Project	<b>IEEE 802.16 Broadband Wireless Access Working Group</b> < <a href="http://ieee802.org/16">http://ieee802.org/16</a> >	
Title	<b>PKM EAP State Machine</b>	
Date Submitted	<b>2004-11-4</b>	
Source(s)	Bryan Kim, Dongkie Lee, JungPyo Han, DongIl Moon, Kang Il Koh  SK Telecom	Voice: +82-31-710-5329 [mailto: {kkhoon, galahad, jphan, dimoon, melomo} @sktelecom.com]
Re:	Sponsor Ballot 16e	
Abstract	PKM EAP state machine and call flow are reflected based on Contribution #407.	
Purpose	Discuss and Adopt as the baseline text	
Notice	This document has been prepared to assist IEEE 802.16. It is offered as a basis for discussion and is not binding on the contributing individual(s) or organization(s). The material in this document is subject to change in form and content after further study. The contributor(s) reserve(s) the right to add, amend or withdraw material contained herein.	
Release	The contributor grants a free, irrevocable license to the IEEE to incorporate material contained in this contribution, and any modifications thereof, in the creation of an IEEE Standards publication; to copyright in the IEEE's name any IEEE Standards publication even though it may include portions

Figure 1 Authorization state machine flow diagram

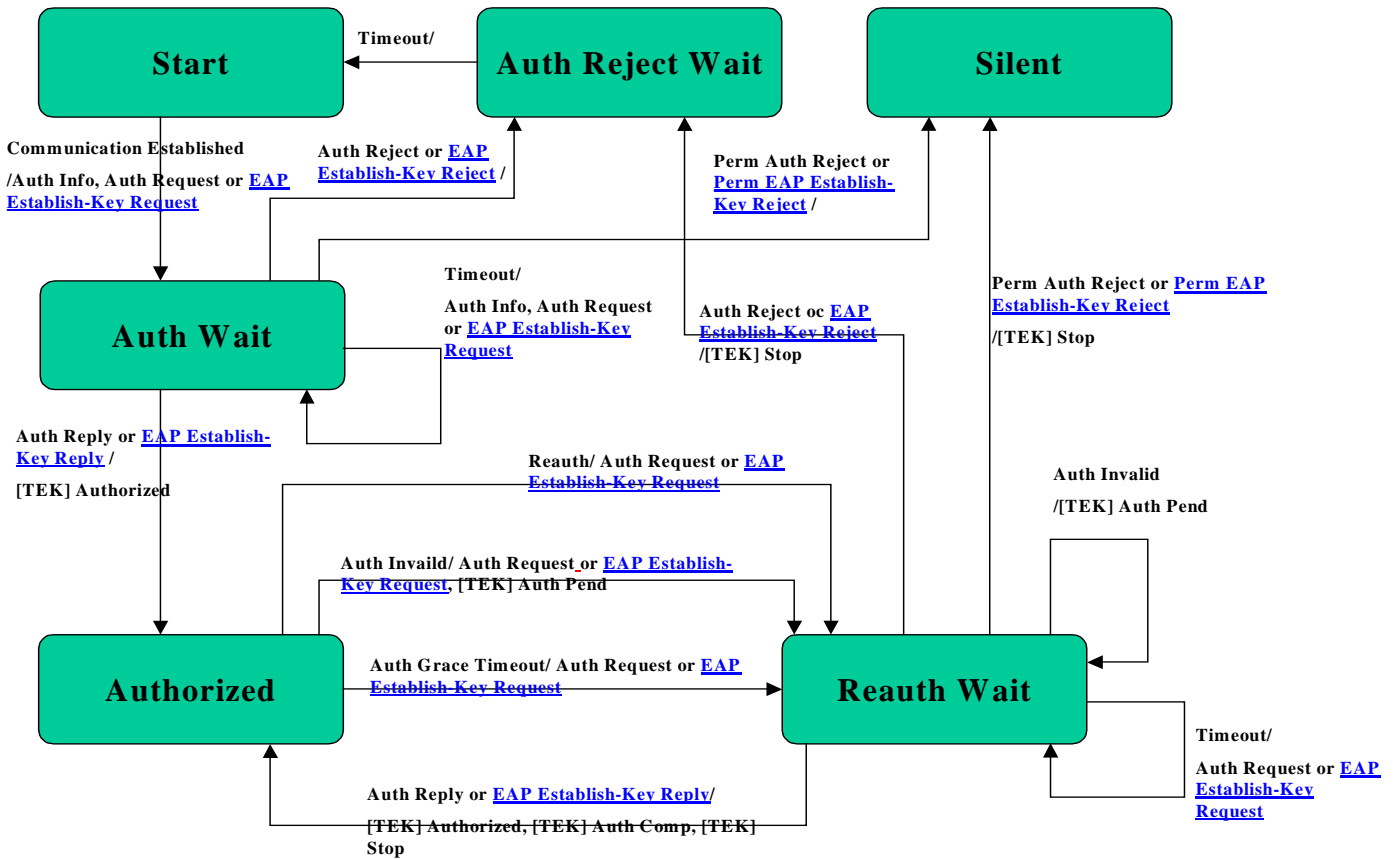
The Authorization state machine consists of six states and eight distinct events (including receipt of messages) that can trigger state transitions. The Authorization finite state machine (FSM) is presented below in a graphical format, as a state flow model (Figure 131), and in a tabular format, as a state transition matrix (Table 131).

the transition>. So “*timeout/Auth Request or EAP Establish-Key Request*” means that the state received a “timeout” event and sent an Authorization Request (“Auth Request”) message *or EAP Establish-Key Request message*. If there are multiple events or messages before the slash “/” separated by a comma, *any* of them can cause the transition. If there are multiple events or messages listed after the slash, *all* of the specified actions shall accompany the transition.

Figure 133 AK management in BS and SS

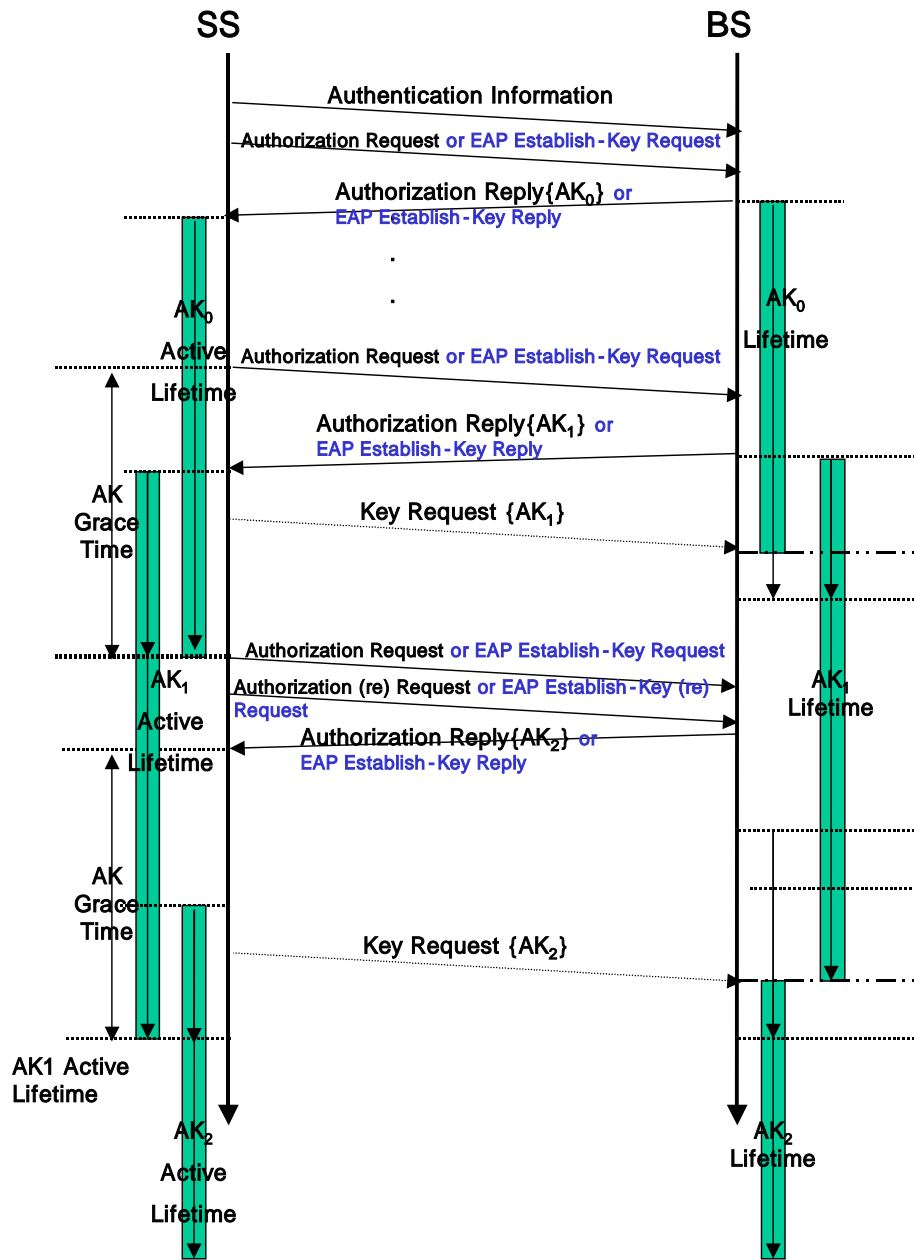
34 An AK transition period begins when the BS receives an Auth Request [or EAP Establish-Key Request](#) message from an SS and  
35 the BS has a single active AK for that SS. In response to this Auth Request [or EAP Establish-Key Request](#), the BS activates a  
36 second AK [see point (a) and (d) in Figure 133], which shall have a key sequence number one greater (modulo 16) than that of the  
37 existing AK and [for PKM RSA case it](#) shall be sent back to the requesting SS in an Auth Reply message. The BS shall set the  
38 active lifetime of this second AK to be the remaining lifetime of the first AK (between points (a) and (c) in Figure 133), plus the  
39 predefined *AK Lifetime*; thus, the second, "newer" key shall remain active for one *AK Lifetime* beyond the expiration of the first,  
40 "older" key. The key transition period shall end with the expiration of the older key. This is depicted on the right-hand side of

43 As long as the BS is in the midst of an SS's AK transition period, and thus is holding two active AKs for that SS, it shall respond  
44 to Auth Request [or EAP Establish-Key Request](#) messages with the newer of the two active keys. Once the older key expires, an  
45 Auth Request [or EAP Establish-Key Request](#) shall trigger the activation of a new AK, and the start of a new key transition period.  
46  
47  
48  
49  
50  
51  
52
